Report on Southern Indiana Gas and Electric Company d/b/a Vectren a CenterPoint Energy Company's 2019-2020 IRP

Submitted to the IURC on November 13, 2020

**Chelsea Hotaling, Energy Futures Group
Anna Sommer, Energy Futures Group
Ric O'Connell, GridLab
Priya Sreedharan, GridLab
Dan Mellinger, Energy Futures Group**

**On behalf of CAC, CGI, Earthjustice, Solarize Indiana,
SUN, Valley Watch, and Vote Solar**

Figure 2. Seasonal Solar and Wind ELCC for 2022-2023

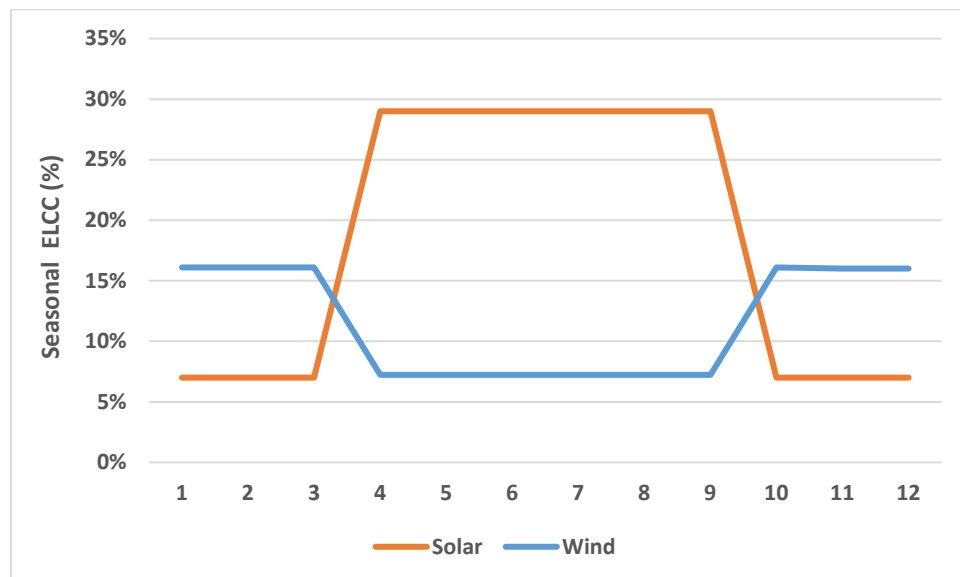
Figure 2 illustrates the seasonal solar and wind ELCC inputs for 2022 and 2023. Vectren modeled a steady decline in the ELCC value of solar each year of about █% during the summer months. By 2039, the solar summer ELCC reaches █% by █ and the winter ELCC reaches █%. The wind ELCC in the summer and winter remains steady throughout the planning period and does not have the same downward trajectory that solar does.

Figure 3. Updated MISO RIA Utility Solar ELCC Curve¹⁸

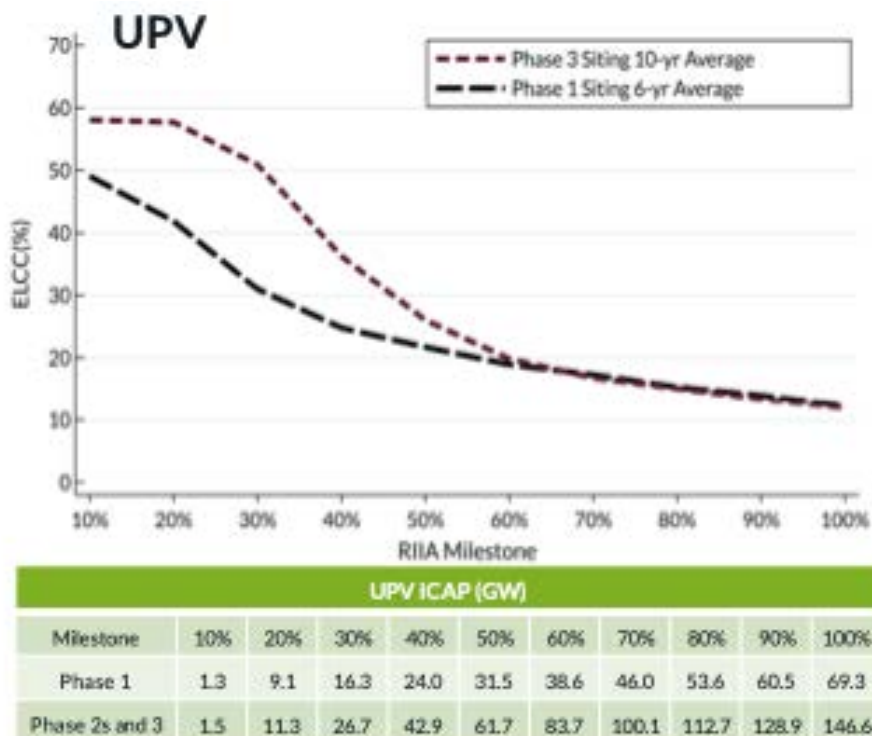
Had Vectren used a more appropriate ELCC for solar resources, the High Tech scenario would not require the two combustion turbine (“CT”) resources Vectren says it needs to meet its capacity obligations. Vectren based its future ELCC values for solar on early versions of MISO’s RIA study that have since been updated, showing Vectren’s assumptions to be overly conservative. Other utilities in MISO, such as IPL and Xcel, have used ELCC values ranging from 50% to 60% for solar. If the solar ELCC is changed to 50%, then Vectren has enough capacity without the two CTs. A 50% ELCC assumption is still quite conservative because, as Figure 3 shows, solar only falls to a 50% ELCC at 30% system-wide penetration or 26.7 GW installed.

Figure 4. High Tech Portfolio with Revised Solar ELCC for 2025

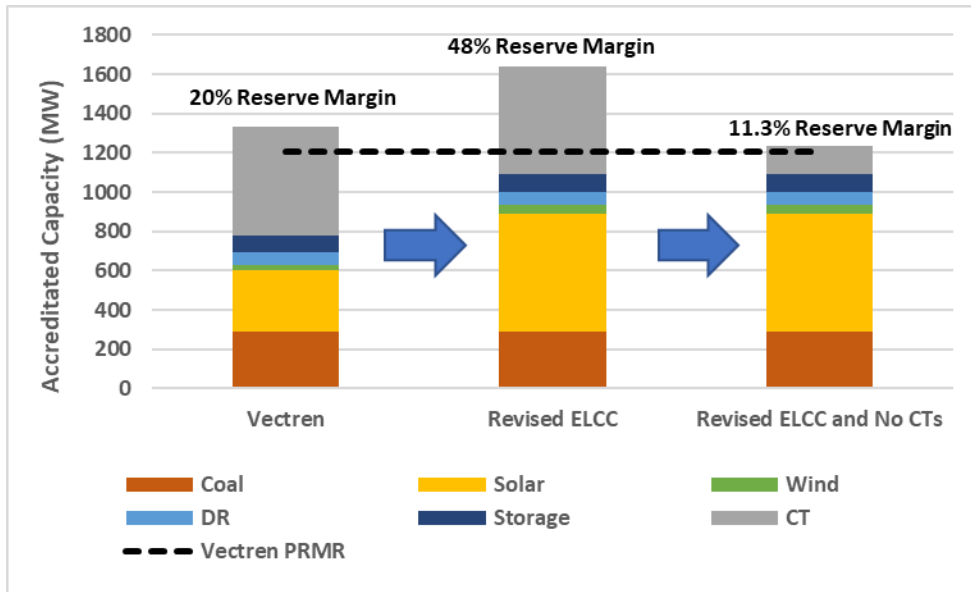
Figure 4 shows the resource accreditation compared to the PRMR for the High Tech portfolio using Vectren’s assumptions (column labeled Vectren), using a 50% ELCC for solar (column labeled Revised ELCC), and using the revised ELCC for solar along with removing the two CTs (Revised ELCC and No CTs). The planning reserve margin across Vectren’s assumptions, the revised solar ELCC, and the revised Solar ELCC in combination with the removal of the two CTs are above Vectren’s █ % planning reserve margin requirement.

Figure 5. All Renewables by 2030 Portfolio with Revised Solar ELCC for 2025

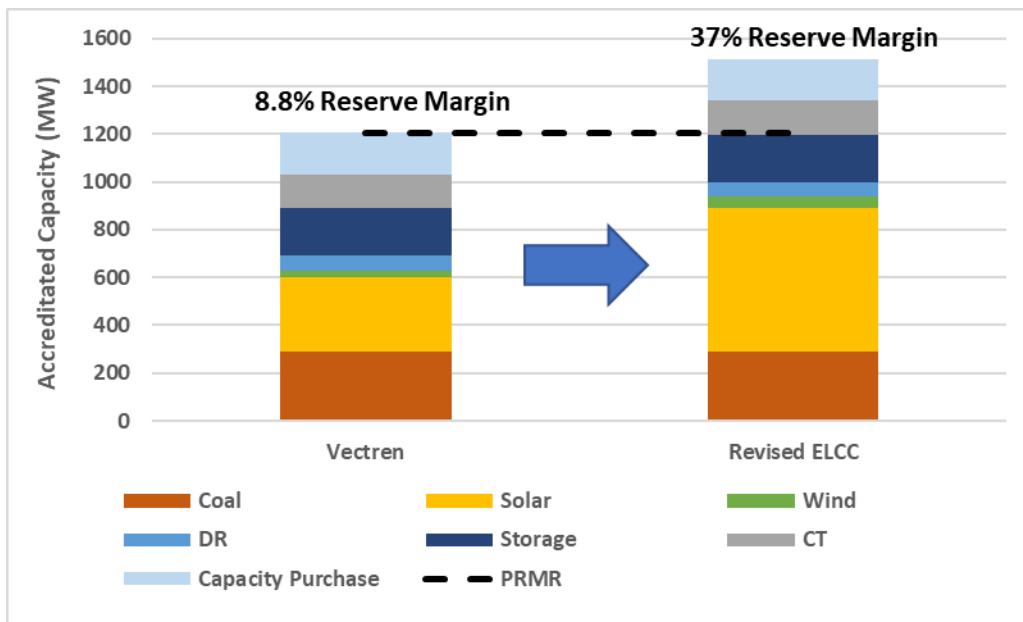
We also used the revised solar ELCC of 50% to evaluate the impact on the All Renewables by 2030 portfolio. Figure 5 below shows that the revised Solar ELCC would eliminate the need for the capacity market purchases in 2025, which would lower the overall cost of the portfolio and reduce its market exposure.

Figure 7. Comparison of Vectren Modeled Battery Storage Capital Costs to NREL²²

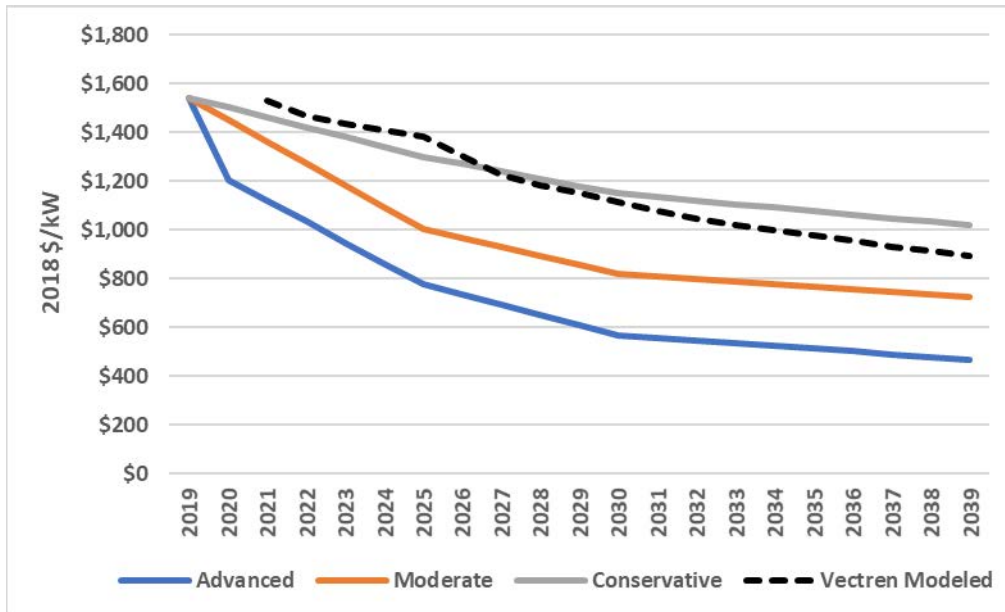
In addition to the concern about the two-year cost shift, we also believe that Vectren is using a conservative capital cost projection for energy storage resources. When the two-year cost shift is then factored into that projection, it makes Vectren’s battery cost projections higher than the Advanced and Moderate cases developed by NREL, which is similar to NREL’s Conservative case. Figure 7 shows the comparison between the capital costs modeled by Vectren against the three cost projections developed by NREL for the 2020 Annual Technology Baseline (“ATB”).

Figure 8. Vectren Sales Forecast by Customer Class³⁰

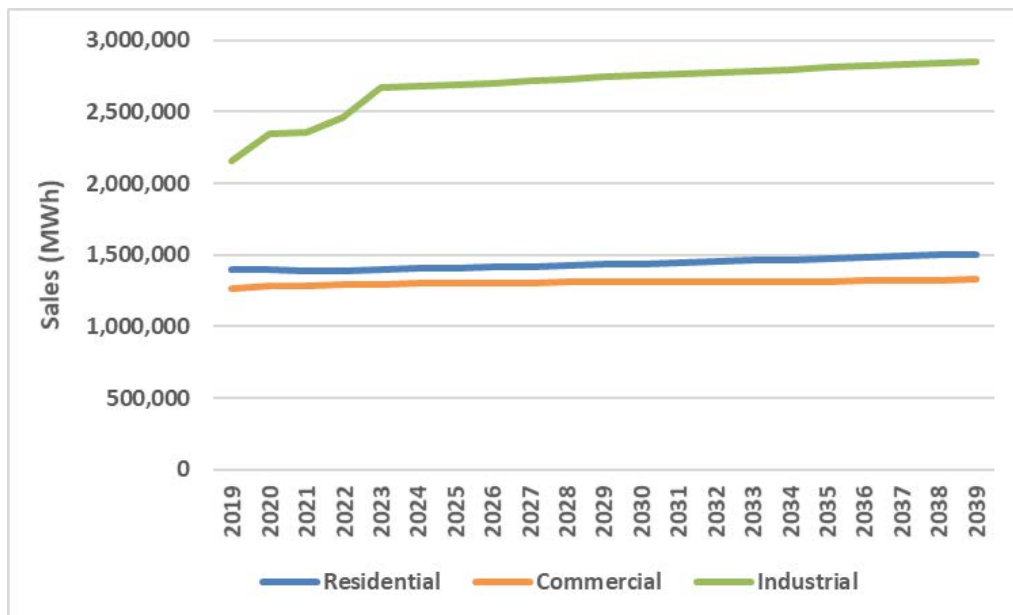
Vectren is forecasting nearly flat sales growth for the residential and commercial classes. On the other hand, Vectren is projecting significant growth from the industrial class between 2019 and 2023 followed by more modest growth thereafter. Vectren’s internal sales forecast is the source of the jump in industrial sales shown in this figure above. We discuss our concerns with this trajectory in Section 4.2.

Figure 9. Industrial Sales Forecast (MWh)³⁵

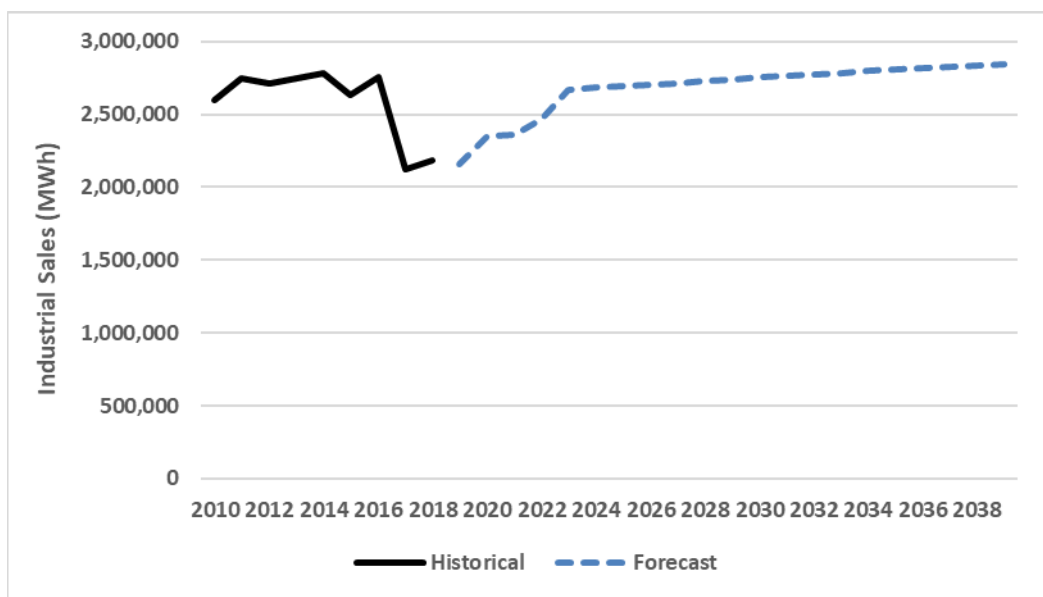
Figure 9 below shows the historical industrial sales for 2010 to 2018 compared to the 2019 to 2039 forecast developed for this IRP. The forecasted average annual growth for Vectren from 2019 to 2023 is 5.50%. The projected sales for 2023 are comparable to the level of sales Vectren had in 2015 before the industrial sales dropped in 2016 due to exiting customers.

Figure 10. Vectren’s Internally Developed Industrial Forecast Compared to Itron’s³⁹

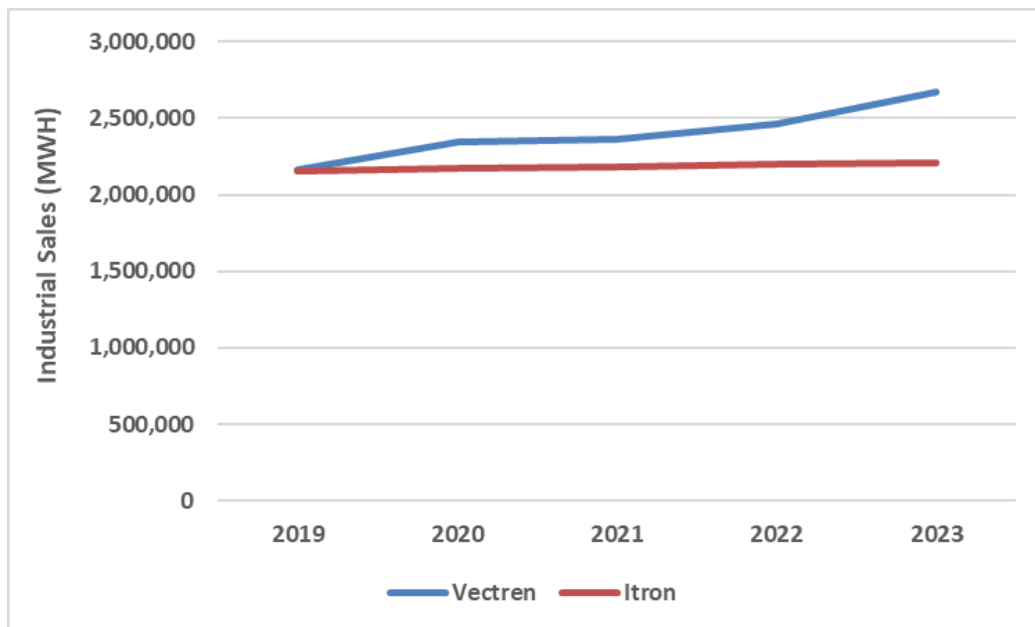
We compared the Itron industrial sales forecast for 2019 to 2023 against the forecast Vectren developed internally. As Figure 10 shows, in contrast to Vectren, Itron projected flat sales for the industrial class from 2019 to 2023.

Figure 11. Comparison of 2016 IRP and 2019-2020 IRP Industrial Sales Forecast (MWh)⁴¹

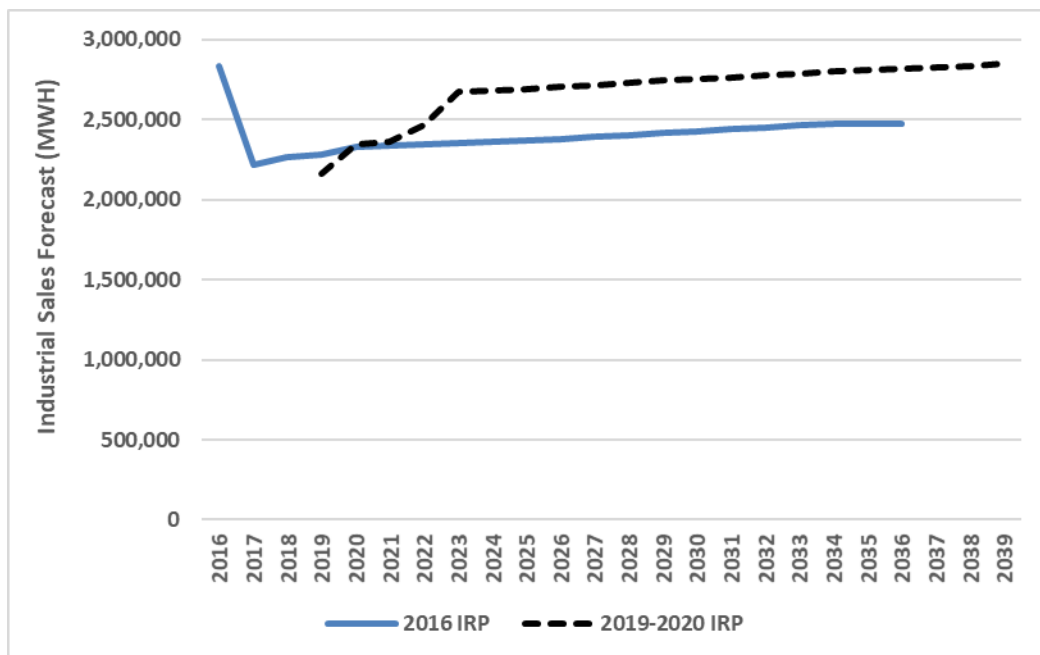
The industrial sales forecast from the 2016 IRP is compared to the industrial sales forecast in this IRP in Figure 11. It is our understanding that the 2016 IRP accounted for load additions Vectren anticipated from several industrial customers that were planning to build facilities within Vectren's service territory. In addition, based on Vectren's description of the forecast outlined above, a 1% buffer was built into the forecast to account for growth not identified by the customer. We are not certain if Vectren has included the anticipated load from the customers identified in the 2016 IRP, but it does appear that the 1% buffer was removed in the forecast developed for this IRP. Even with these modifications, the forecast for this IRP is significantly higher than the 2016 IRP forecast. If new load in the 2019-2020 forecast is indeed the product of just one customer's growth, this further raises the question about the likelihood of that happening. Either way, this load growth has not been substantiated by Vectren in any way.

Figure 12. Energy Efficiency Supply Curve for 2024⁴⁷

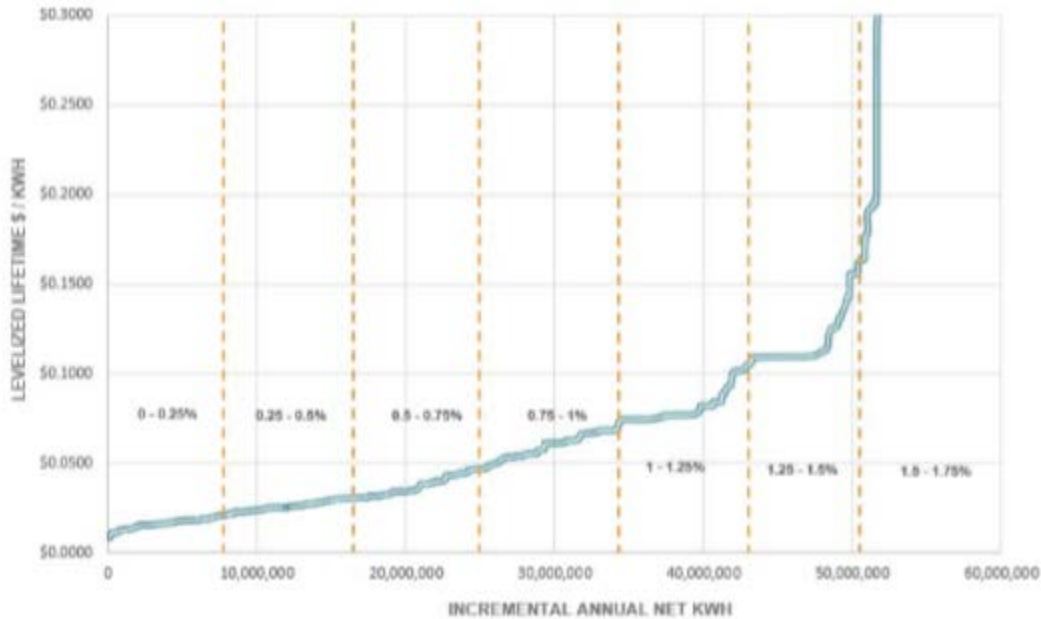
We also think this approach could be masking a result that even more EE would be cost-effective. If Figure 12, below, were reworked to present the MPS savings by program type, then the supply curve of EE would look much more flat. This is because the less expensive measures would average out the costs of the more expensive measures, the result of which would almost certainly be the selection of additional EE as long as not all the bundles are “optimal.” If all of the bins were grouped into one, then the overall levelized cost would be \$ [REDACTED] per MWh. This is in contrast to the \$ [REDACTED] per MWh levelized cost of Bin 5, which is the last bin forced in by Vectren. If all bins were optimal, the model should take them all regardless of how measures were grouped. However, without forcing in additional bundles, Vectren would not know if additional EE were similar in cost to the “optimal” level in the same way that Bins 4 and 5 were similar in cost.
